D-206.05

RE: Dauphin River First Nation Environmental Act Proposal for Wastewater Treatment Lagoon Construction Liner Alteration

enc. Plan L3 - Dikes Details - Revision 1

Jason Cousin, P. Eng.
Municipal Engineer

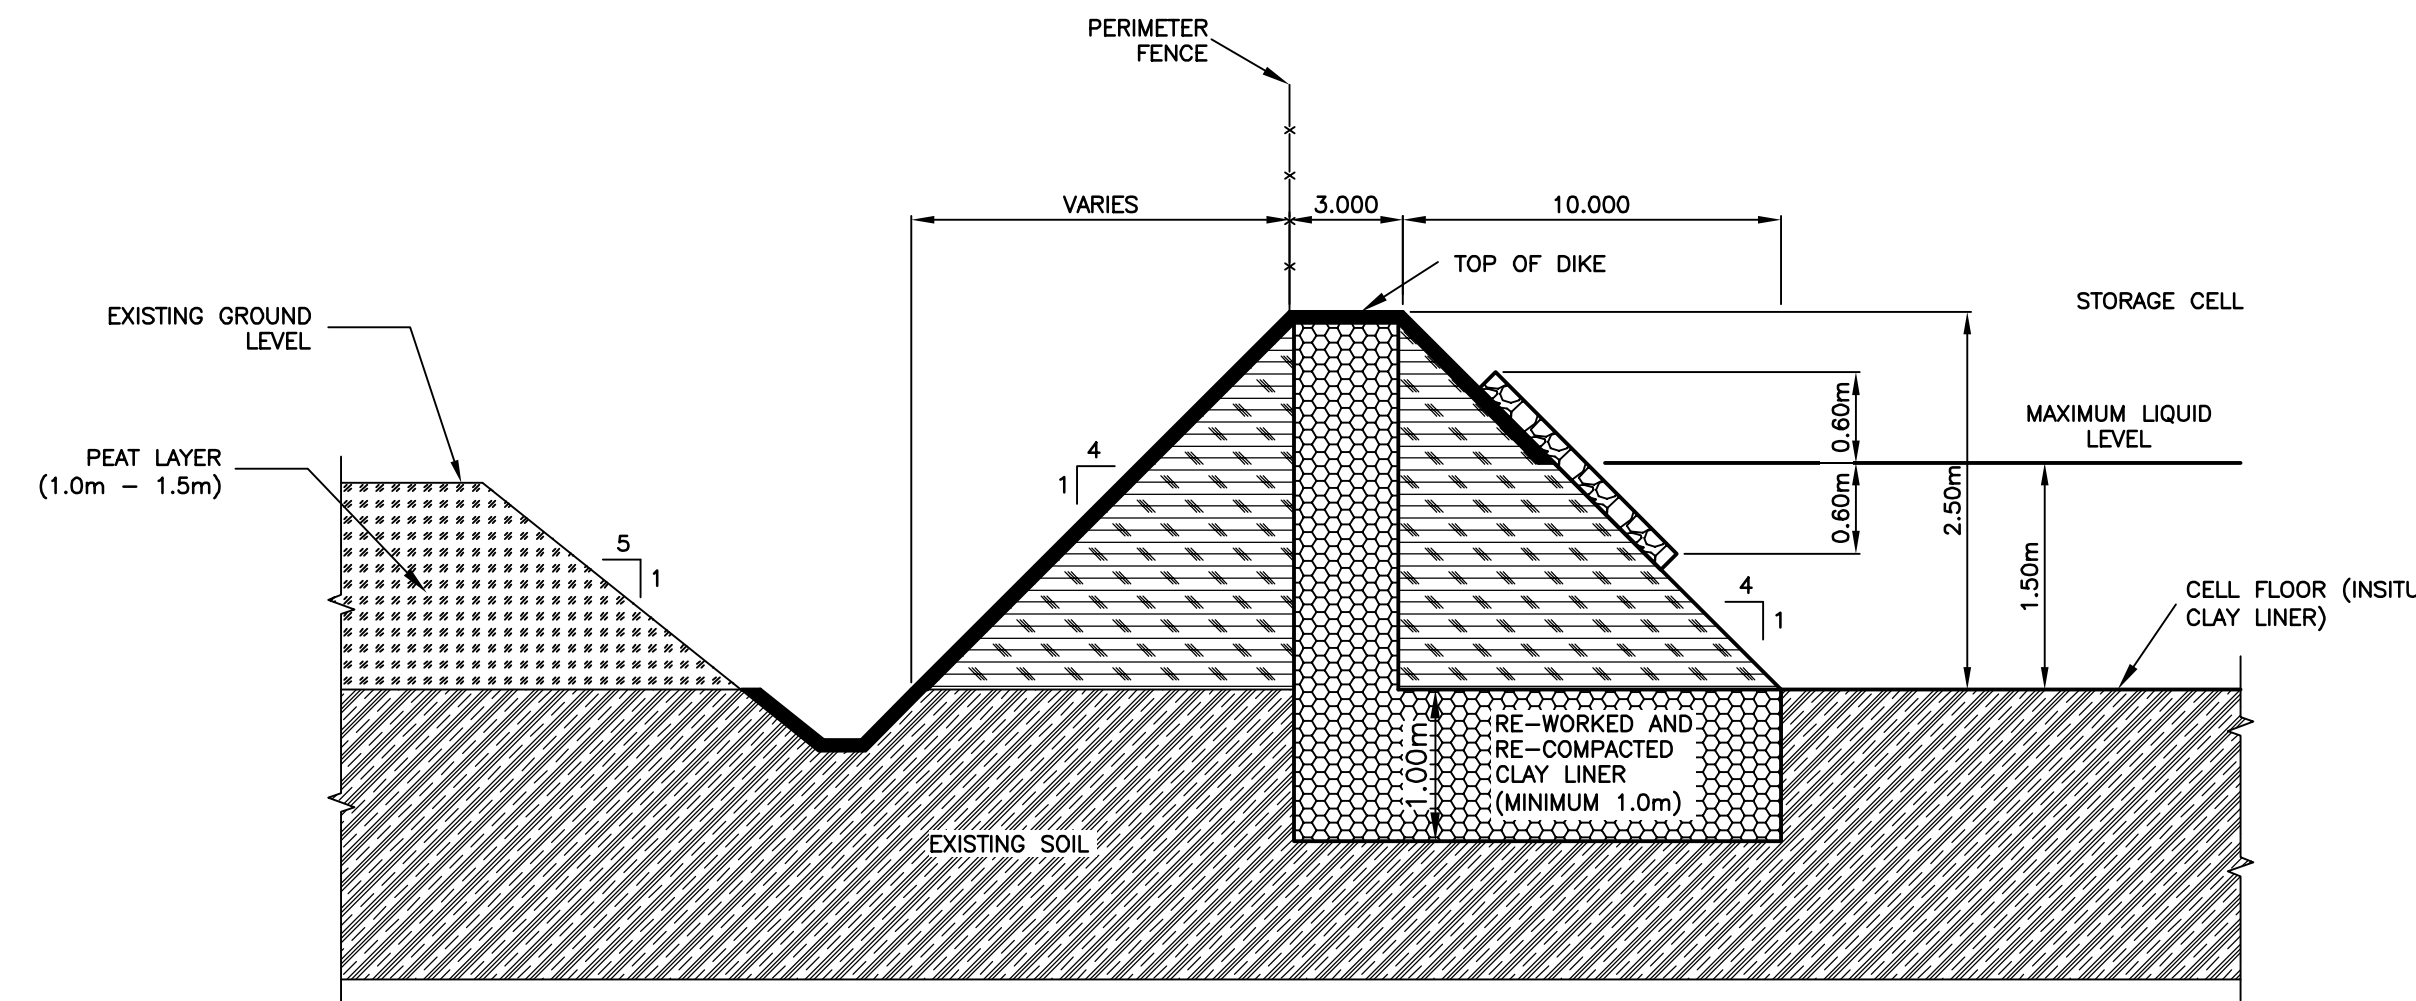
The initial Environmental Act Proposal submitted for the Dauphin River First Nation lagoon identified a 1 m thick remolded clay liner. Since the original submission in April 2015 additional geotechnical investigations have been completed onsite, along with additional design works.

During the geotechnical investigation completed by AMEC Foster Wheeler in April 2015 and subsequent testing completed in May 2015, tests results show samples collected of the insitu clay soils meet the liner requirements of 1×10^{-7} cm/s. Instead of remolding the entire site as presented in the original EAP, the design has changed to only remold 1 m thick the soil under the keyway and inside slope of the perimeter dikes and under the intercell dike. (as identified on the attached plan L3) Should areas be found to have insufficient depth of clay during the excavation of the lagoon perimeter remolded liner, additional excavation will continue into the cell floor to confirm the availability of the minimum 1 m thick insitu clay liner.

B.M. EL.
1	LINER REVISION	15/10/02	RH	LOCATIONS OF UNDERGROUND STRUCTURES/UTILITIES AS SHOWN ARE BASED ON AVAILABLE INFORMATION BUT NO GUARANTEE IS GIVEN OR IMPLIED THAT ALL EXISTING UNDERGROUND STRUCTURES/UTILITIES ARE SHOWN OR THAT THE GIVEN LOCATIONS ARE EXACT. CONFIRMATION OF EXISTENCE AND EXACT LOCATION OF ALL UNDERGROUND STRUCTURES/UTILITIES MUST BE OBTAINED FROM THE APPROPRIATE AUTHORITY/OWNER, BY THE CONTRACTOR, BEFORE PROCEEDING WITH CONSTRUCTION.					
No.	REVISIONS	DATE	INITIALS
